TOWN OF EAST GREENBUSH
PLANNING BOARD

EAST GREENBUSH PLANNING BOARD
MEETING MINUTES
JUNE 26, 2019

Motion (17-19)
Town Center Planned Development District Recommendation to the Town Board

EXHIBIT D
CONCEPT PLAN
TOWN CENTER PDD
580 COLUMBIA TURNPIKE
Town: EAST GREENBUSH County: RENSSELAER State: NEW YORK

EXHIBIT R
AREA SUMMARY
TOWN CENTER PDD
580 COLUMBIA TURNPIKE

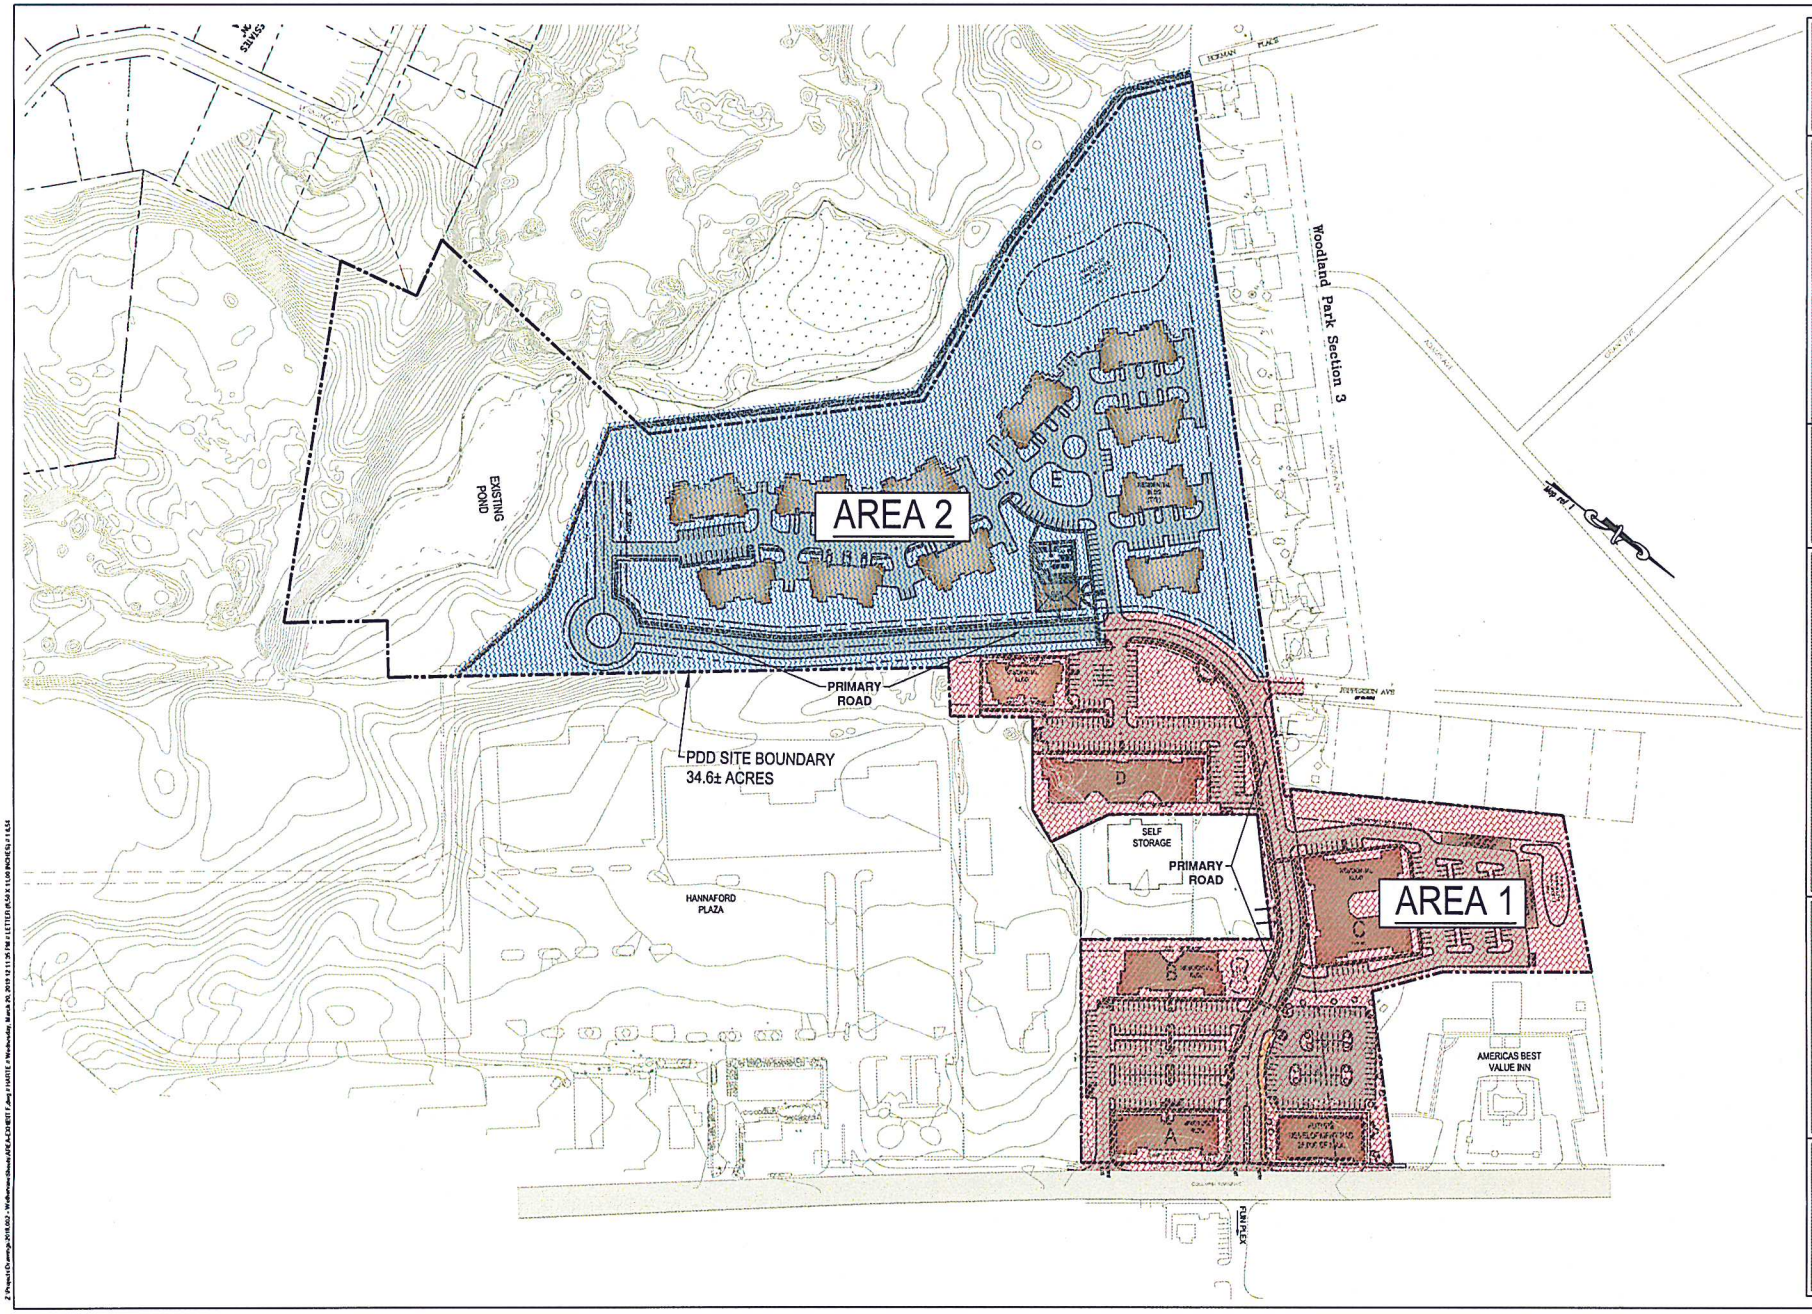
For land use zoning purposes, the site would be divided into two sections as shown on Exhibit R Area Summary. Proposed uses are summarized below.

The Planning Board further recommends that, per Section 2.9.A.D of the Town's Comprehensive Zoning Law, the proposed local law be modified to state "Where standards are not changed or established in the PDD, the standards of the underlying zoning district shall be noted appropriately." Therefore, the standards in the B-1 and R-B zones prior to implementation of the PDD and rezoning must apply unless otherwise stated.
